Groundwater Application Review Summary Form

Application # G- 18642 (Re-review)

TO: Water Rights Section Date 5/20/2019
 FROM: Groundwater Section Benjamin Scandella, Jen Woody
 Reviewer's Name
 SUBJECT: Application G-18642 Supersedes review of 12/21/2018
 Date of Review(s)

A. GENERAL INFORMATION: Applicant's Name: JACKSON FAMILY INVESTMENTS III LLC County: YAMHILL

Figure 2. Water levels in Nearby Wells

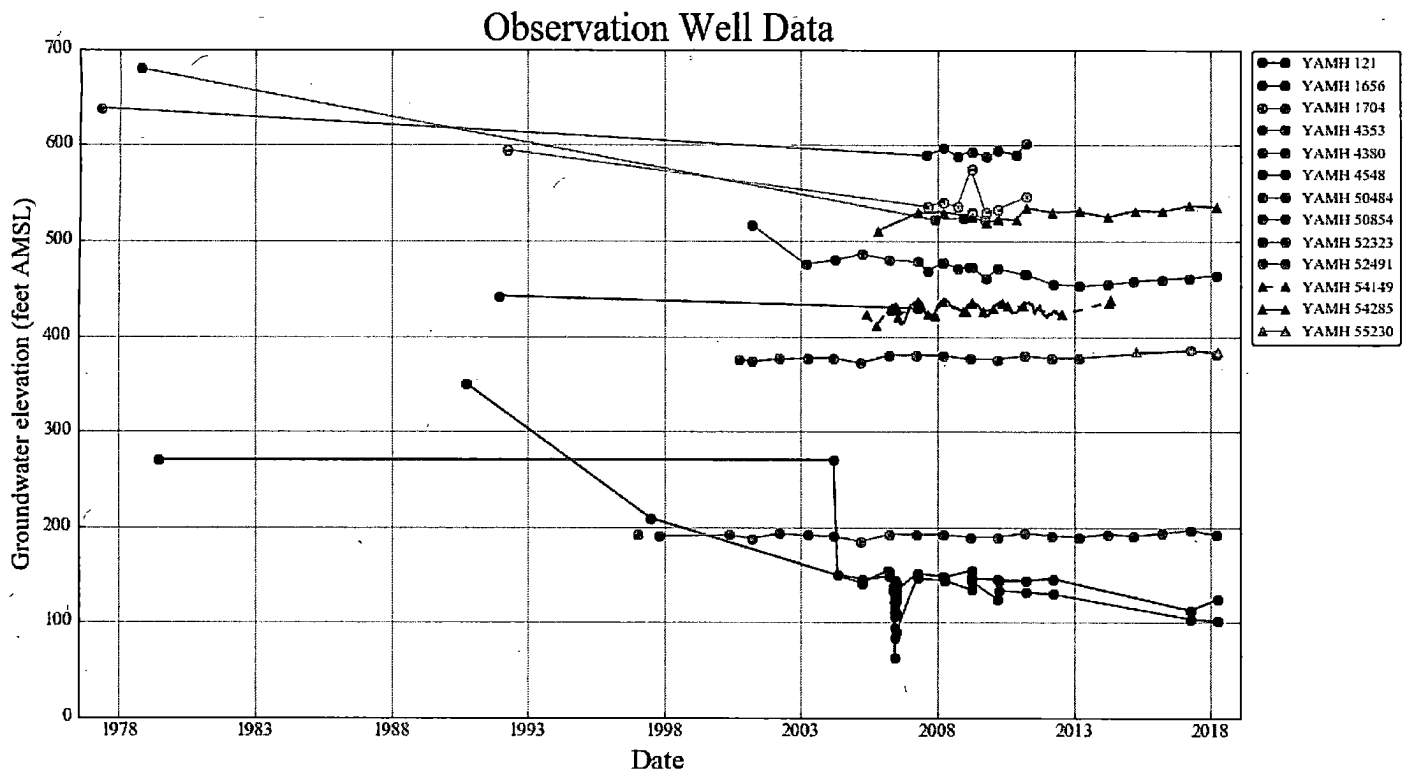
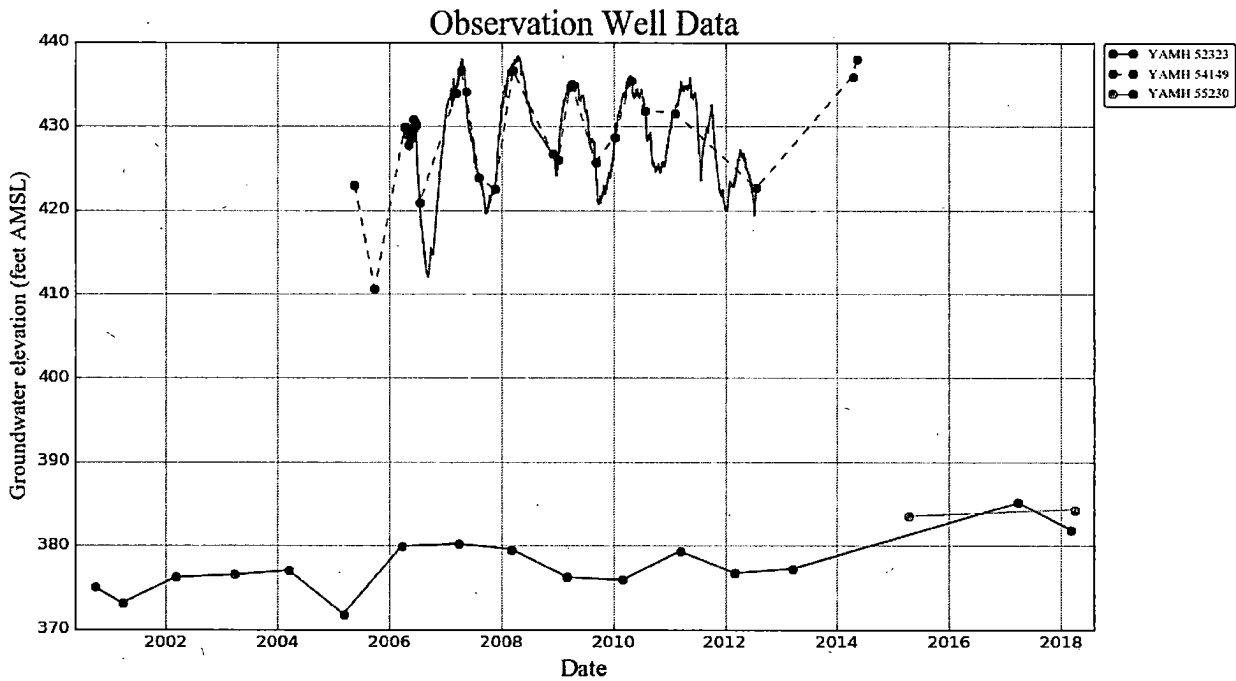
Water levels in wells located higher on the hill and to the West show relatively stable trends (see Figures 2 and 3), while wells located to the East (YAMH 50854, YAMH 4548, and YAMH 121) show evidence of long-term decline. YAMH 52323 (YAMH 52323) is among the former group and has shown relatively stable water levels for the entire period of record, from 2000-2018. Given the nearby location nearly identical proposed construction for the proposed well, it is expected to access the same water-bearing zones and show similar water levels to YAMH 52323. The two water-bearing zones in YAMH 52323 appear to be hydraulically connected, given their identical water levels in the well log, and they are likely also connected with water-bearing zones accessed by nearby wells (see Figures 1 and 4). However, the proposed magnitude of development is not expected to cause injurious well-to-well interference with neighbors or long-term water level decline. Water use and water level monitoring conditions are recommended to protect existing users.
